NRC DOCKET 50-366
OPERATING LICENSE NPF-5
EDWIN I. HATCH NUCLEAR PLANT UNIT 2
BUILDING SETTLEMENT

Your letter of July 20, 1979, requested additional information with regard to our proposed Technical Specifications for settlement of Category I structures. The request for additional information was further clarified in a meeting with your staff on August 30, 1979.

The attached report responds to the questions asked by your July 20, 1979, letter and the concerns discussed at the August 30, 1979, meeting.

FIGURE A.1-1: REFERENCE BENCHMARKS
(SHT. 2 OF 2)

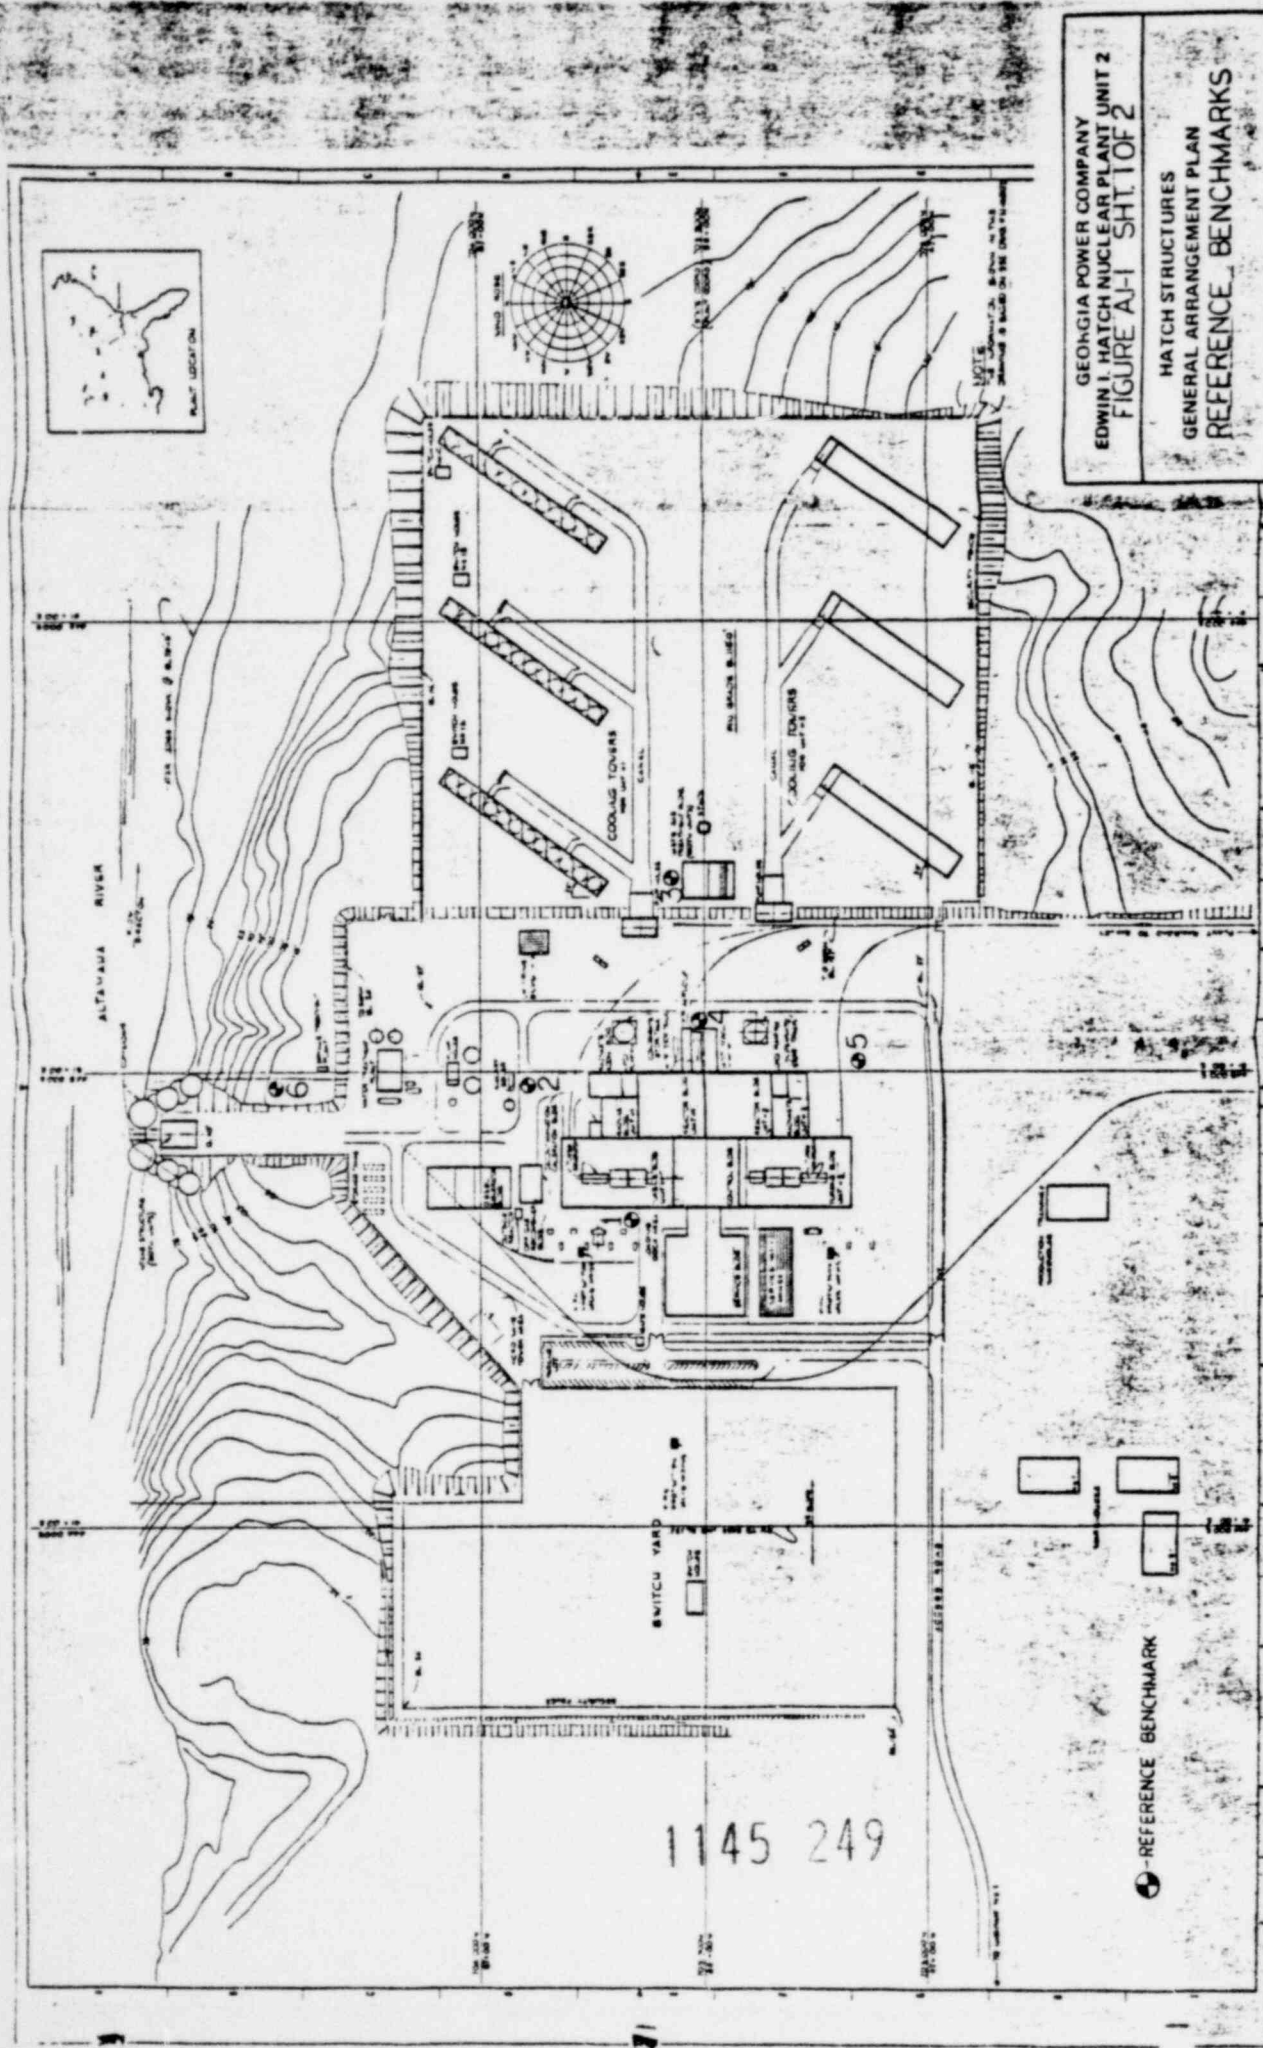
- A.1 The locations of the reference benchmarks are shown in Figure A.1-1. Elevations of the benchmarks were originally established from a USGS benchmark in Toombs County. The benchmarks are situated in the yard in such a way as to avoid accidental displacement and facilitate the settlement surveys of the Category I buildings. They are far enough away to avoid settling with the buildings and are placed in areas isolated from traffic which might disturb the marker. Precautions were also taken to provide proper soil and anchorage conditions to ensure the stability of the benchmarks. There is no procedure for periodically checking the elevations of the reference benchmarks.

FIGURE A.4-1: RELATIVE LOCATIONS OF BENCHMARKS AND PENETRATIONS
PARTIAL PLAN EAST WALL - EL. 130'-0" - REACTOR BUILDING UNIT 2

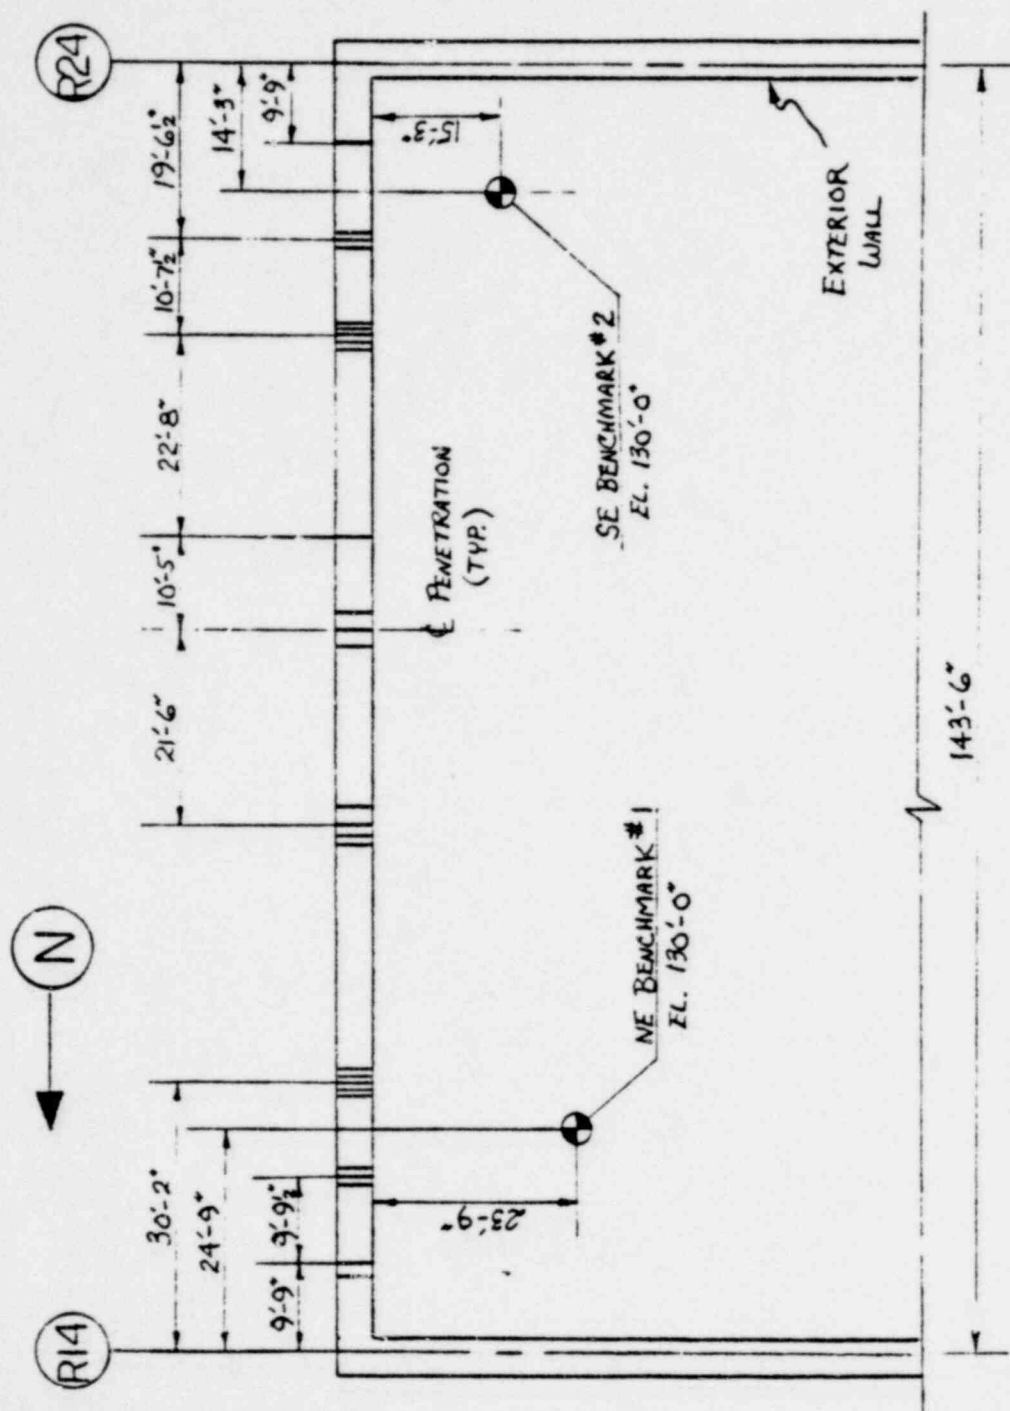
A.4 The relative locations of all penetrations, including electrical conduit penetrations, with respect to the benchmarks for the east wall of the Unit 2 Reactor Building are shown in Figures A.4-1 and A.4-2. The arrangement shown is typical for all the Category I structures.

The assumption made in developing the Technical Specification was that the settlement at a particular penetration was the settlement recorded at the nearest benchmark. Since in almost all cases the piping was installed in the penetrations well after the buildings were complete (see Figures A.6-1 and A.6-2), building adjustments during construction, such as concrete shrinkage, cracking, creep, etc. had stabilized, and therefore what was measured was due to differential settlement. Allowance was also made to allow building settlement to occur before attaching the pipe to the penetration (see bottom detail Figure D.3-2), which would further allow the building itself to adjust.

FIGURE B.1-1: CONDUIT EXPANSION COUPLING DETAIL

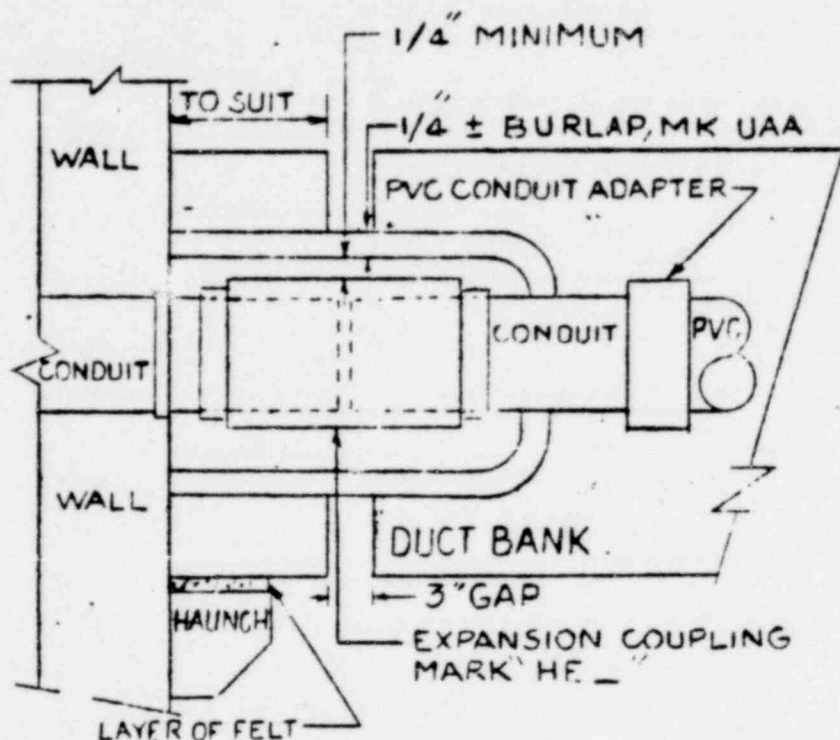
The proposed Technical Specification directly addresses all piping and potential structural damage due to excessive differential settlement. There are electrical conduits which run from the buildings out into the yard and between the structures, but they use flexible connections which allow 3/4" differential movement in any direction per the manufacturer's specification. A typical expansion coupling detail is shown in Figure B.1-1. There are no Category I sheet metal-type ducts which run between buildings or from one building out into the yard.

FIGURE D.3-1: TYPICAL PENETRATION ANCHOR DETAIL

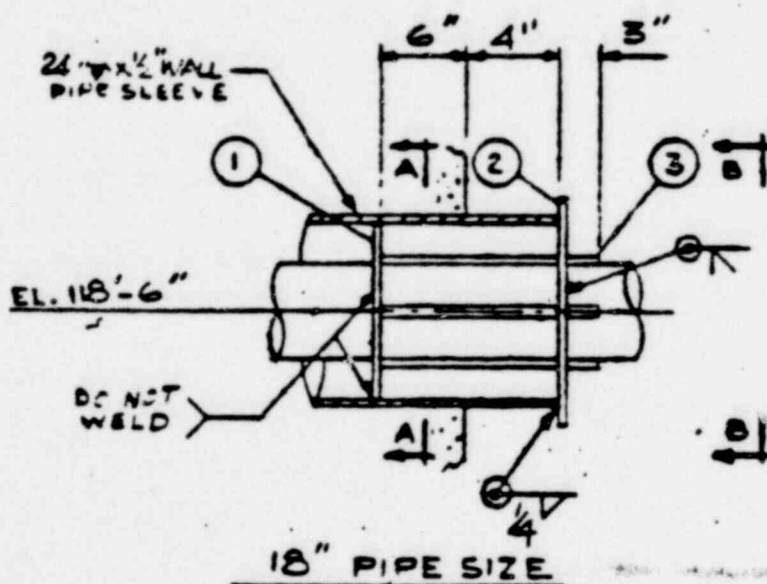
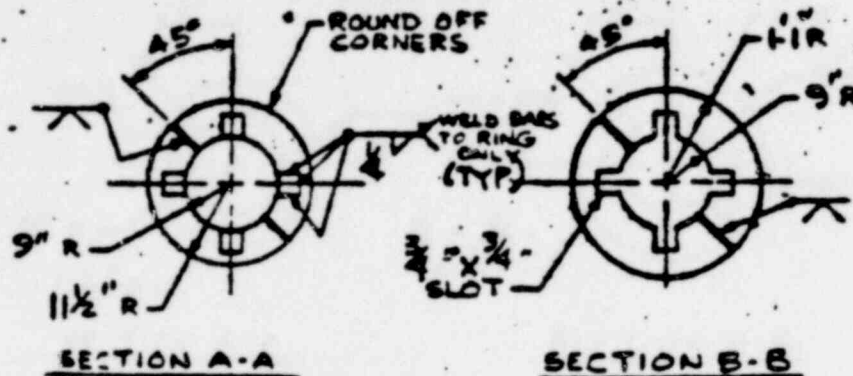
- D.3 A detailed sketch of a typical penetration anchor is shown in Figure D.3-1. As is shown, the anchor is located at the interior side of the wall penetration. Additional penetration details are shown in Figure D.3-2. A description of each penetration type is provided in the figures.

By definition, the penetration anchors are designed to take moments, shears and axial loads. They are not constituted of snubber-like devices although an effort was made to reduce the load on the anchors due to building settlement by allowing the building to settle as much as possible before setting the penetration anchor (see bottom detail of Figure D.3-2). The HNP-2 FSAR Section 3.9 covers the design and analysis requirements for the HNP-2 Class I piping. The load types and loading combinations used in the original design of the piping and piping supports are those found in the Winter 1972 Addenda to the ASME Boiler and Pressure Vessel Code, Section III, 1972. The loads considered were sustained, dynamic, and thermal and combinations of the three. The safety margins provided by the anchors are the margins provided by the ASME Code, 1972. Stresses due to building settlement were not considered either in the FSAR or the revision of the ASME code that the original design was based on.
